January 16, 2025

ADDENDUM #4

Coastal Carolina Community College
Learning Resources Center
First Floor Renovation
SCO ID: 23-26060-01A

Sheet No.
Addendum #4,
Attachment #6

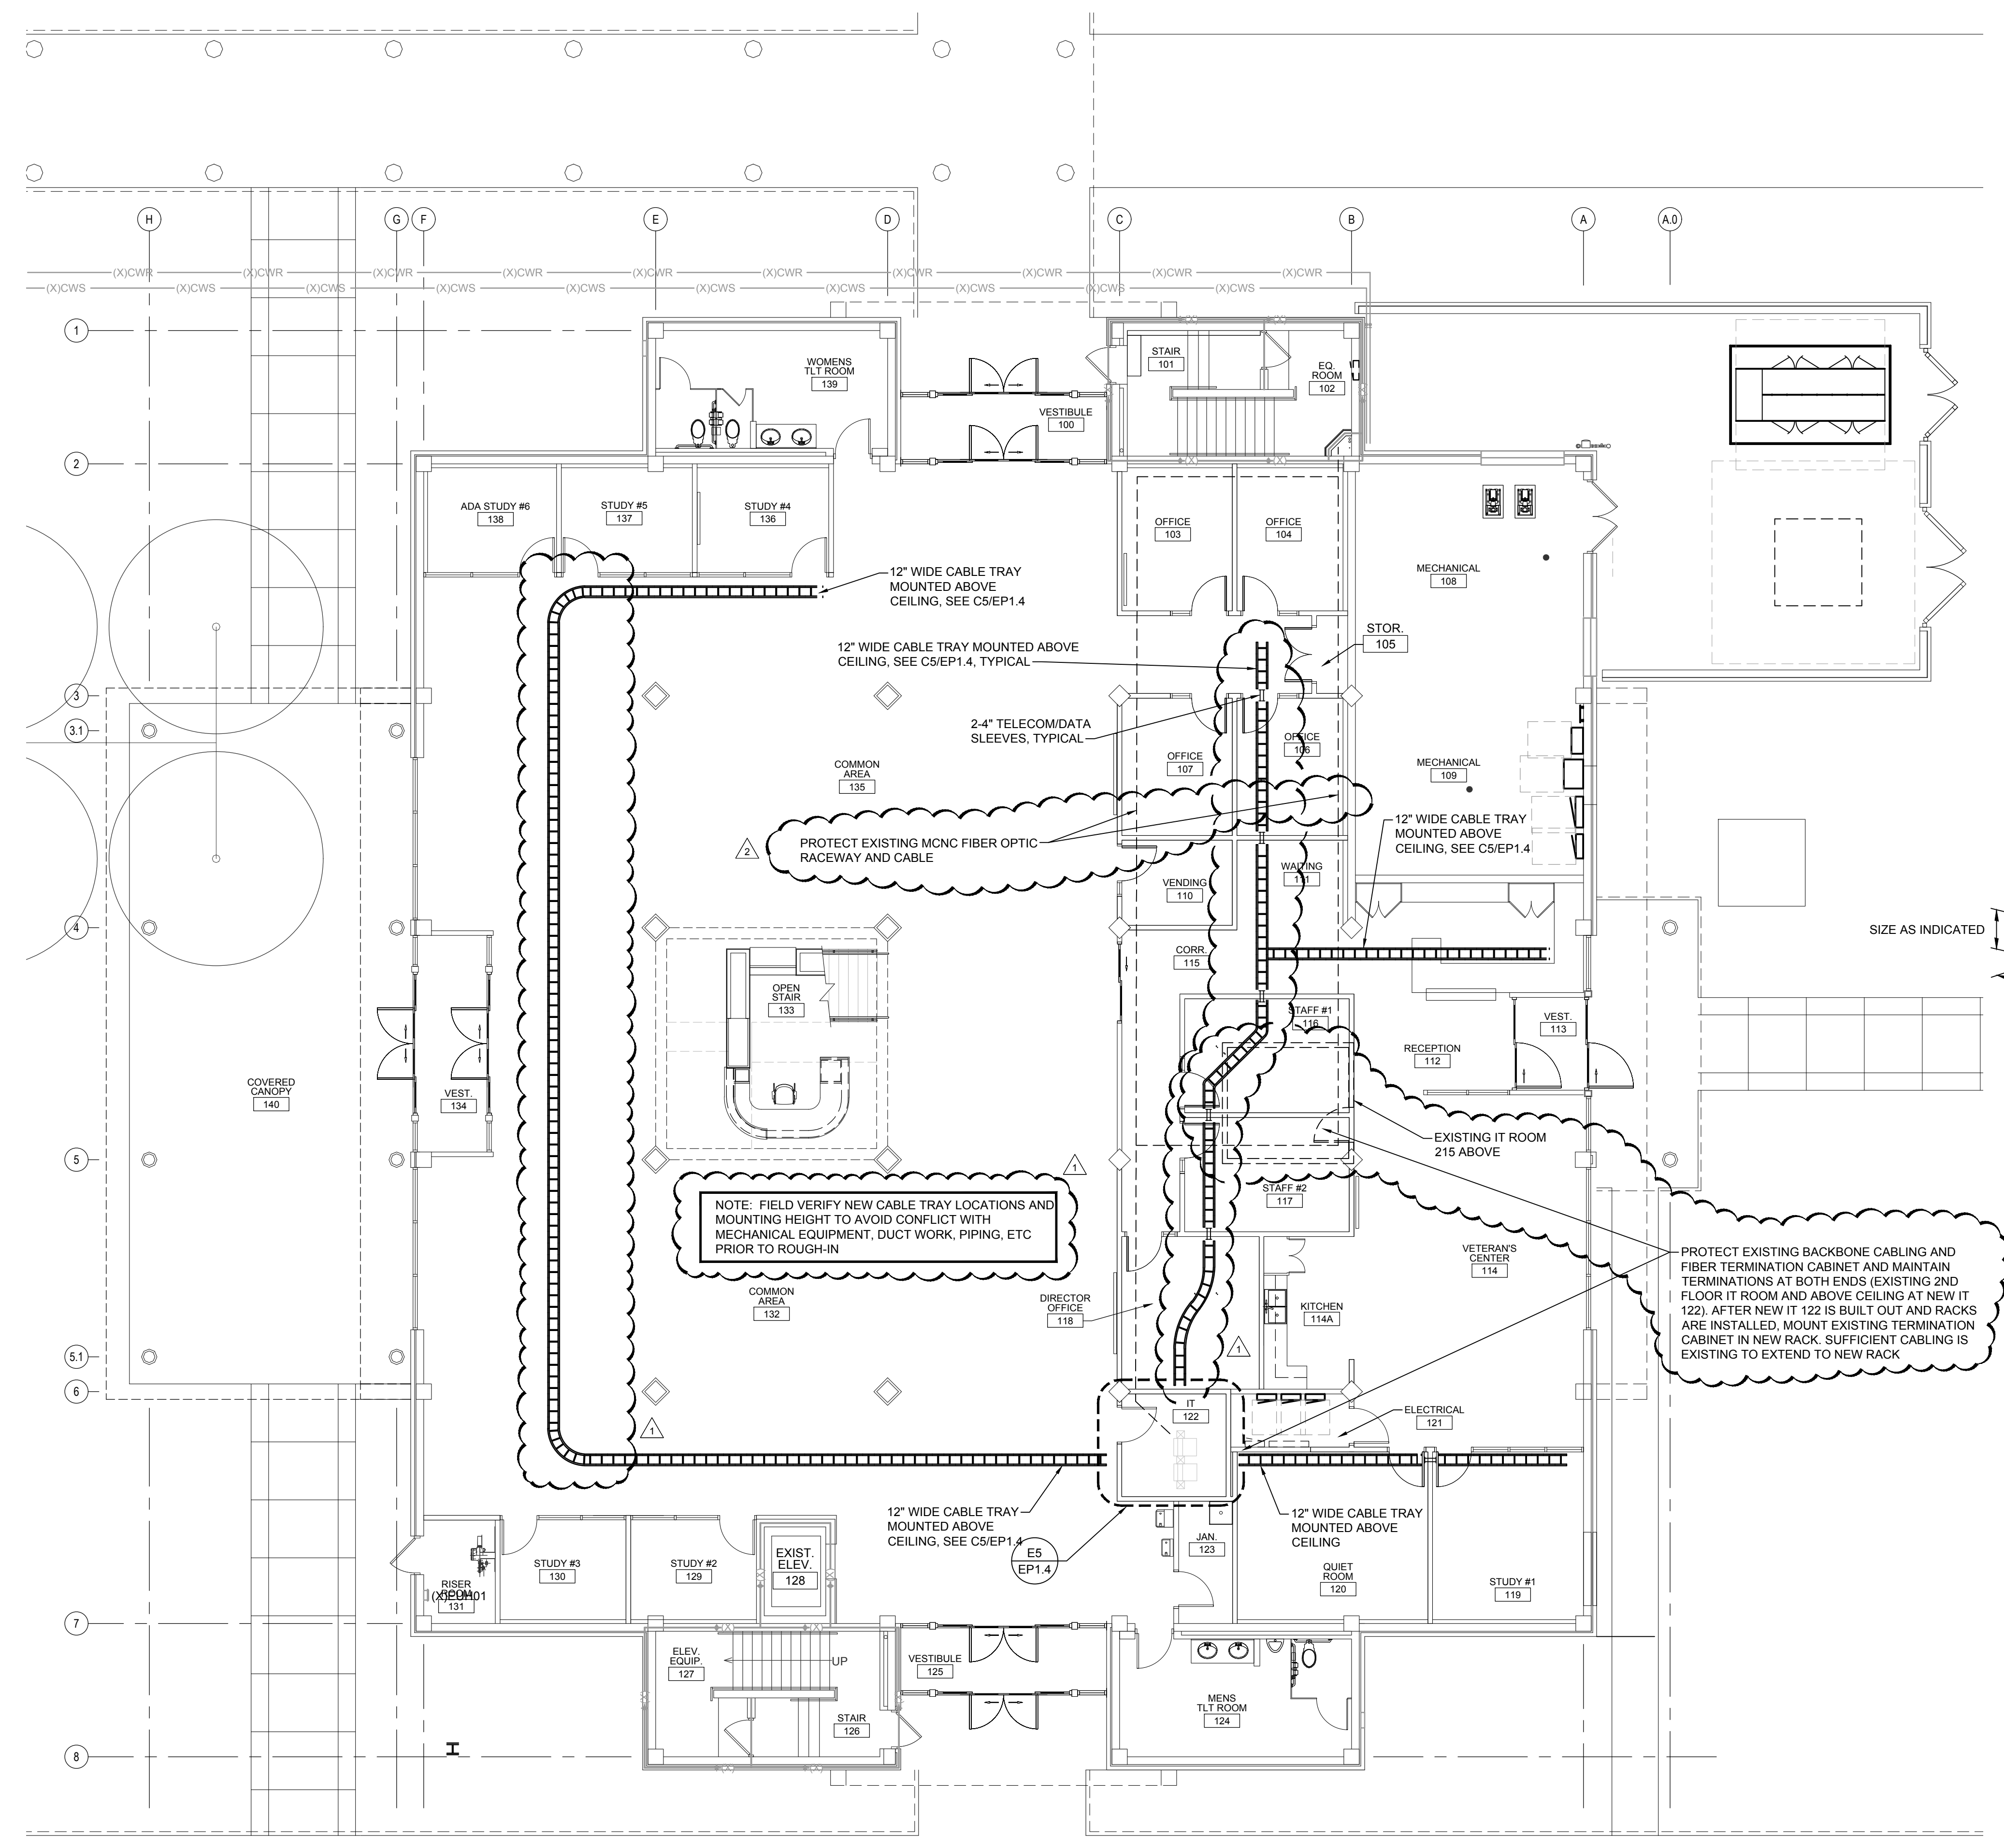
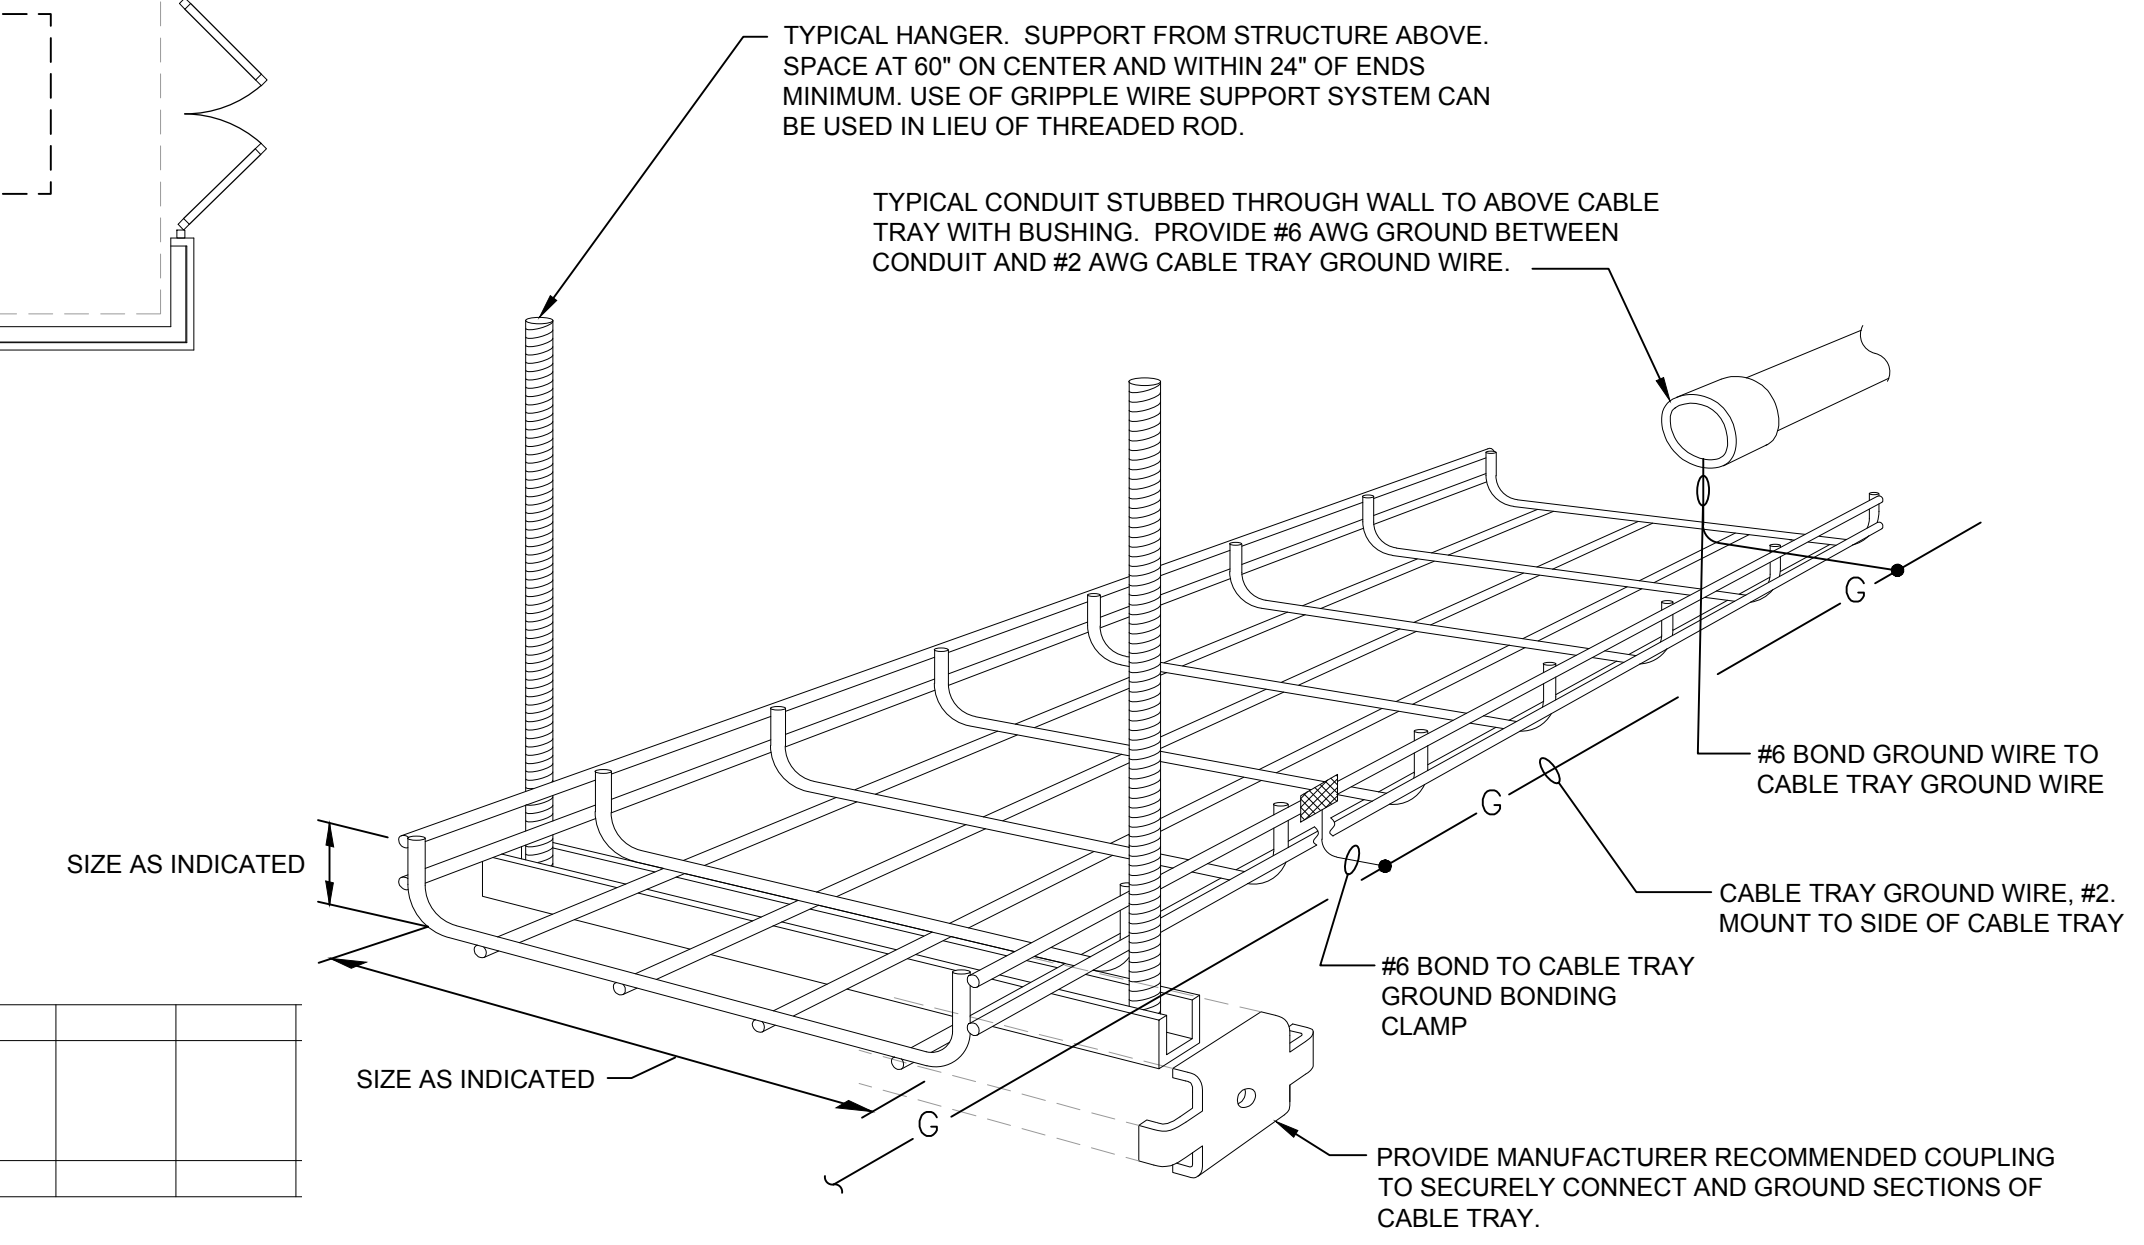
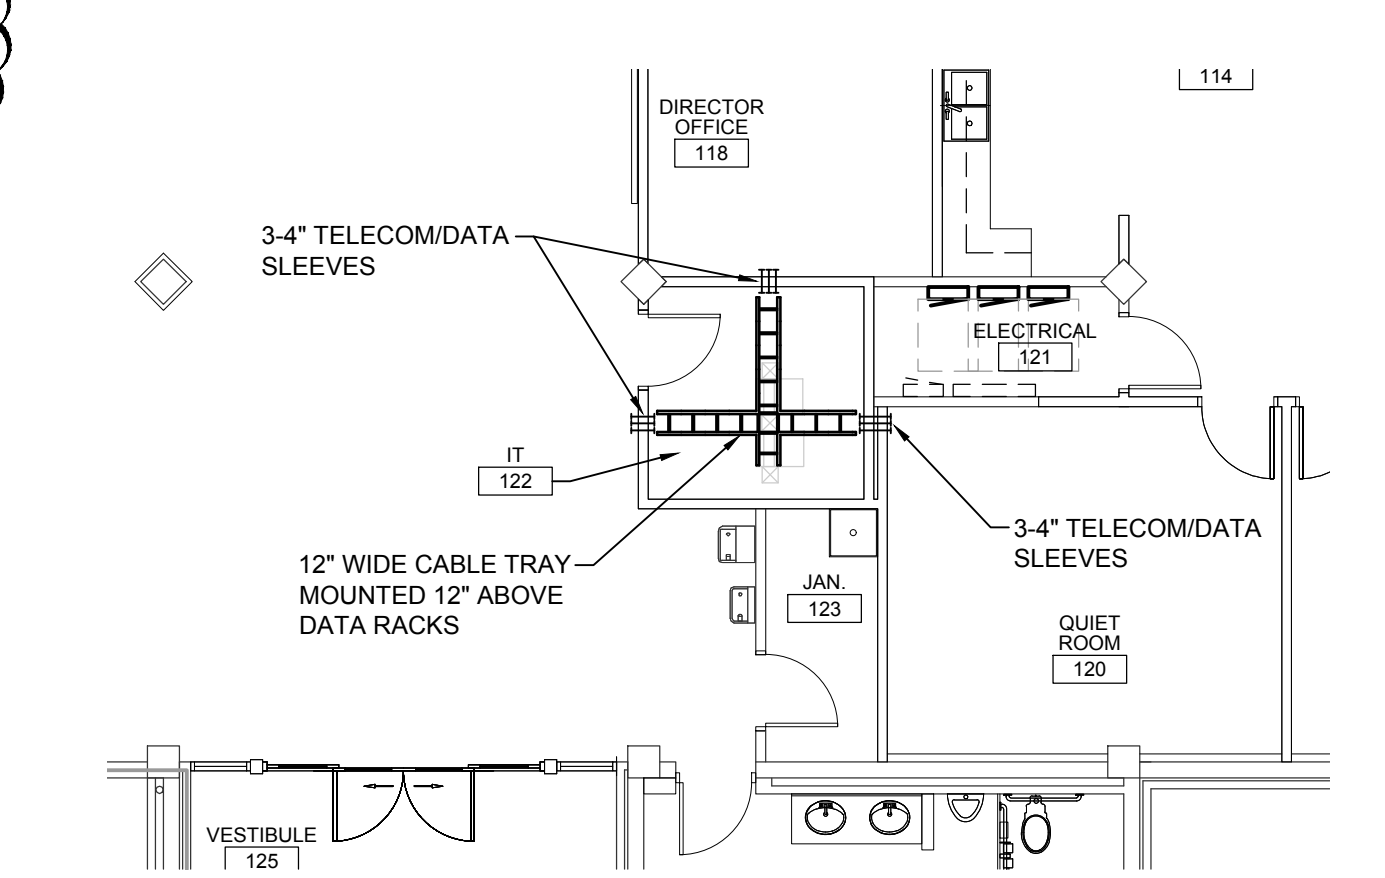
Revised drawing sheet EP1.4 calls for existing MCNC fiber optic raceway and cable to be protected during construction.
